LARAMIE COUNTY PLANNING & DEVELOPMENT DEPARTMENT

MEMORANDUM

TITLE: PUBLIC HEARING on a Subdivision Permit and Plat for Fertig Ranch subdivision, Situated in the NW ¼ of Section 11, T14N, R65W of the 6th P.M., Laramie County, WY.

AGENCY REVIEW COMMENTS #3

RECCO TRACTS 2ND FILING

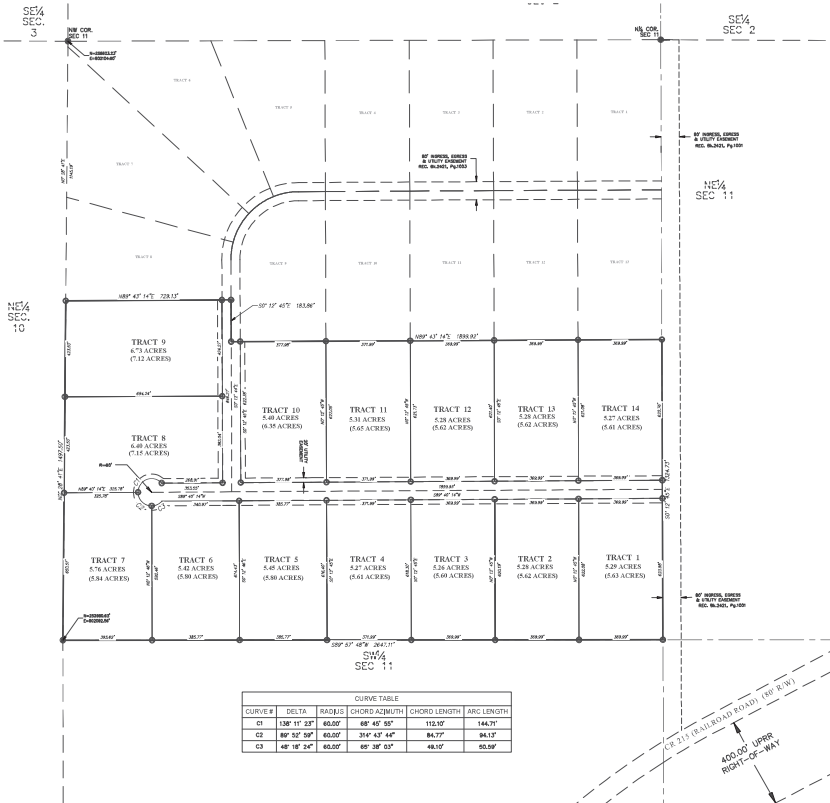
- 4.The plat drawing indicates the area is served by LCFD No. 3, but it should be served by LCFA.
- 5.Since it appears this plat is dedicating the ROW for the roadways, names for the roadways should be provided. In addition, the widths of the ROW need to be labeled on the plat.
- 6.There is an existing sign just north of Railroad Road that indicates it is private property and no trespassing. However, with this subdivision the easements that allow for ingress/egress into this subdivision, the sign needs to be removed.
- 7.In the Dedication, there are two bearings that dont match the bearings labeled on the plat drawing. One is N89 degrees 43'14"W versus N89 degrees 43'14"E, and the other is N0 degrees 28'11"E versus N0 degrees 28'41"E.

- 1.Is the southwest corner of this subdivision the West Corner of Section 11, if so it should be labeled.
- 2.The differences of bearings and distances between this subdivision and the RECCO TRACTS records of survey are not shown on this plat.
- 3.The VACATION STATEMENT on this plat describes the vacation of an ACCESS EASEMENT recorded in BOOK 2421, AT PAGE 1001, however the RECCO TRACTS records of survey state that the easement is recorded at PAGE 1003. Are these referencing the same easement?
- 4.There is one label identifying a 20 UTILITY EASEMENT, however there is more than one easement shown on the plat. Either a note or an additional label would help clarify intent.

11/21/2024		Workflow	PUBLIC WORKS REVIEW	GENERAL	<p>1. All comments from the review engineer and surveyor shall be addressed and/or acknowledged.</p> <p>2. With this development, the ingress, egress and utility easements shown on the plat and those outside the boundaries of this plat (Book 2421, Pg 1001 and Book 2421, Pg 10003) shall be designed and built to the current Laramie County Land Use Regulations. The road construction design plans shall be submitted to Laramie County Public Works for review and approval prior to construction taking place.</p> <p>3. If the roadways will be constructed in phases, please show the phasing plan within the next submittal.</p> <p>4. A note shall be added to the plat indicating "All Tracts are to be accessed off internal roadways/access easements."</p> <p>5. Note 3 on the plat shall be updated to say (with the determined road names) "Road name 1, road name 2 and road name 3 will not be maintained by Laramie County."</p> <p>6. Access permit applications through Public Works will be required for each tract. Call (307-633-4302) or email (permits@laramiecountywv.gov) Public Works for more information.</p> <p>7. The access location onto Road 215 shall meet the current Laramie County Land Use Regulations.</p>	MOLLY.BENNETT@LARAMIECOUNTYWV.GOV

06/02/2026		Workflow	PUBLIC WORKS REVIEW	DEFICIENCY	<p>1. No responses to comments submitted. The following comment still apply:</p> <p>a. The comment responses seem to contradict each other. The review engineer mentioned building of the roadways and the response comment indicated that would not be done. Public Works made a comment regarding the roadways needing to be built (inside and outside the plat boundary), and that was acknowledged. So which is it?</p> <p>b. the following comment from Public Works still stands:</p> <p>b1. With this development, the ingress, egress and utility easements shown on the plat and those outside the boundaries of this plat (Book 2421, Pg 1001 and Book 2421, Pg 10003) shall be designed and built to the current Laramie County Land Use Regulations. The road construction design plans shall be submitted to Laramie County Public Works for review and approval prior to construction taking place.</p> <p>b2. Raymond Trail and Recco Ranch Road shall also be built to County Standards.</p> <p>2. I agree with the comments provided by the review engineer.</p>	MOLLY.BENNETT@LARAMIECOUNTY.WY.GOV

<p>1. Acknowledged</p> <p>2. Corrected</p>	
					<p>THE ONLY THING THAT CHANGED WITH THIS ALREADY APPROVED PLAT IS THE REMOVAL OF 1 TRACT.</p>	
06/02/2026		Workflow	PUBLIC WORKS REVIEW	DEFICIENCY	<p>1. No responses to comments submitted. The following comment still apply:</p> <p>a. The comment responses seem to contradict each other. The review engineer mentioned building of the roadways and the response comment indicated that would not be done. Public Works made a comment regarding the roadways needing to be built (inside and outside the plat boundary), and that was acknowledged. So which is it?</p> <p>b. the following comment from Public Works still stands:</p> <p>b1. With this development, the ingress, egress and utility easements shown on the plat and those outside the boundaries of this plat (Book 2421, Pg 1001 and Book 2421, Pg 10003) shall be designed and built to the current Laramie County Land Use Regulations. The road construction design plans shall be submitted to Laramie County Public Works for review and approval prior to construction taking place.</p> <p>b2. Raymond Trail and Recco Ranch Road shall also be built to County Standards.</p> <p>2. I agree with the comments provided by the review engineer.</p>	MOLLY.BENNETT@LARAMIECOUNTY.WY.GOV

<p>1. responses were submitted to previous comments.</p> <p>2. It will be done as indicated previously.</p> <p>3. Acknowledged</p> <p>4. Acknowledged</p> <p>5. Acknowledged</p> <p>6. Acknowledged</p>
